Driveway Review Form

WO #: 20-010664

Address: 21 Lincoln St

Permit #: TB-20-1823

Property

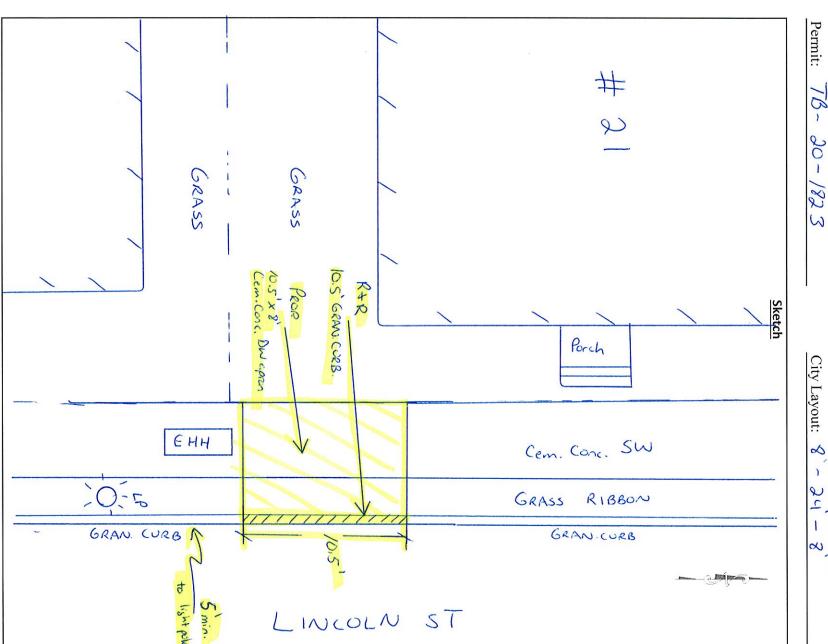
Granite Curb: Remove and return 10.5' granite curb.

DPI Specs. **Must maintain 5' buffer from apron to light pole south of prop.DW. grass ribbon. 3.Install new 10.5'x8' cem.conc.DW apron in accordance with the most current Additonal Inspection Notes: 1.R&R 10.5 gran.curb. 2.Remove 10.5'x8' cem.conc.SW &
